March 11, 2008

In Reply Refer To: HSSD/CC-69E

Thank you for your December 14, 2007, letter requesting Federal Highway Administration (FHWA) acceptance of an extension to the Road Systems, Inc., Single Sided Crash Cushion (SSCC) as a test level 3 (TL-3) device for use on the National Highway System (NHS). You requested that we find the extended SSCC acceptable for use on the NHS under the provisions of National Cooperative Highway Research Program (NCHRP) Report 350 "Recommended Procedures for the Safety Performance Evaluation of Highway Features."

BEAT-SSCC  
Single Sided Crash Cushion  
Variable Length  
System Configurations

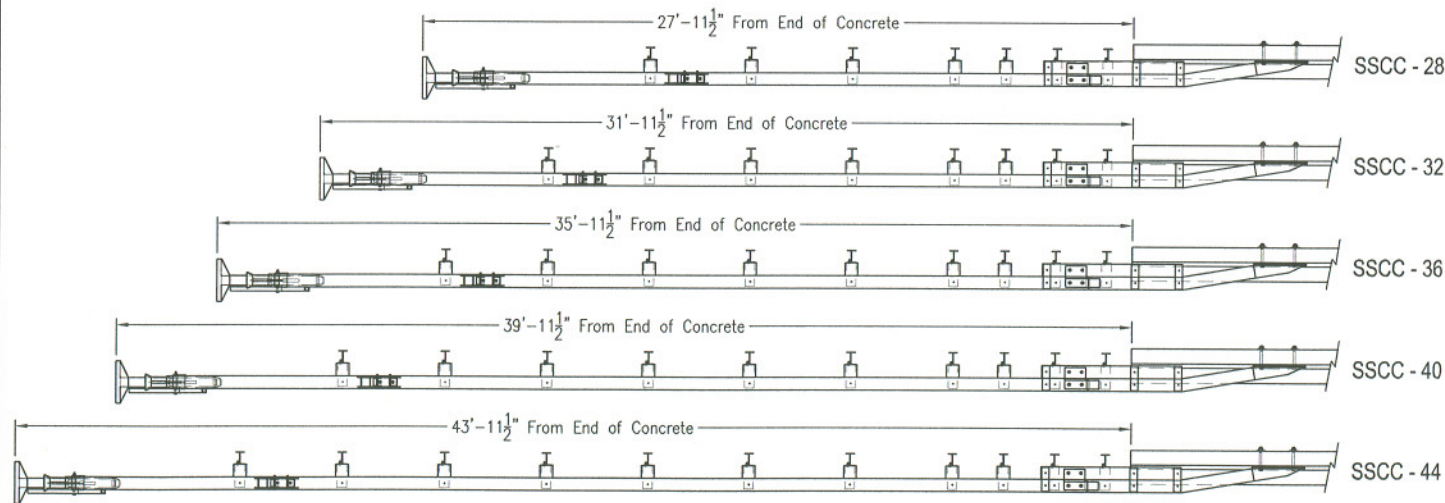
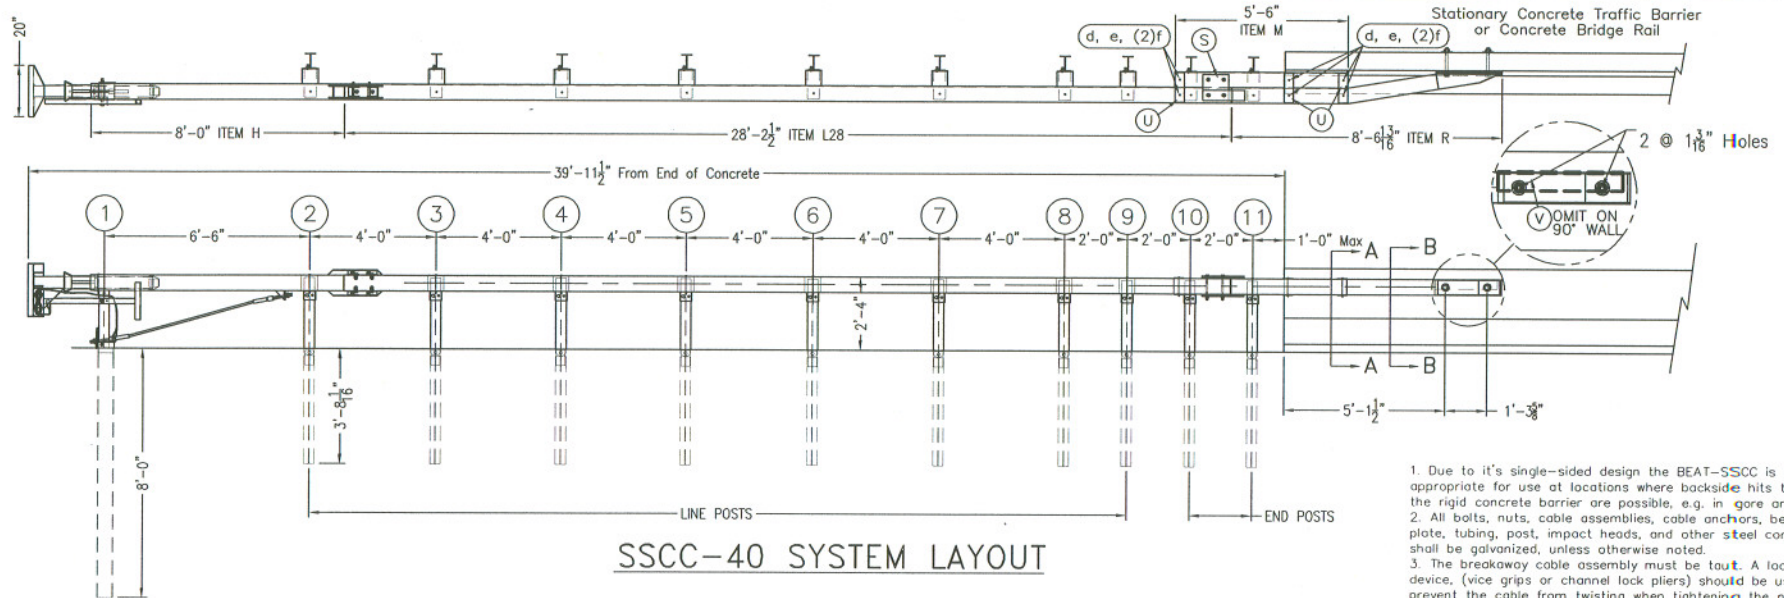
The SSCC was originally accepted by FHWA in 2002 (CC-69B) in a soil mounted configuration and in 2004 (CC-69D) in a pavement mounted option. Both of these designs incorporate a 27 ft – 11.5 inch long design with a total of 8 breakaway posts. The spacing between the first and second post was 6 feet 6 inches. The next three posts were spaced 4 feet apart, and the final three posts were reduced to 2 feet apart. It is proposed that the SSCC be lengthened by incorporating additional box beam railing in the 4 foot post spacing region. As shown on the enclosed drawing, extensions of 4, 8, 12, and 16 feet are proposed.

Test 30, Test 31, Test 32, Test 33 all involve end-on impacts. As the proposed change extends the second stage energy absorber, the only effect would be to increase the terminal's energy dissipation capacity for end-on impacts.

Test 34 and Test 35 involve impacts on the side. As the proposed extension does not introduce components that would change the terminal's redirective capacity, there is no need to run either test.

Test 39 is a reverse direction test. As was the case for the same-direction side impacts discussed above, no new design elements are introduced to alter the redirection capability of the device.

We concur in your claim that the optional extension of the SSCC would not adversely affect the crashworthy performance of the device. Therefore, the requested modification is acceptable for use on the NHS, when permitted by a highway or transportation authority, under the range of conditions the original design was tested.
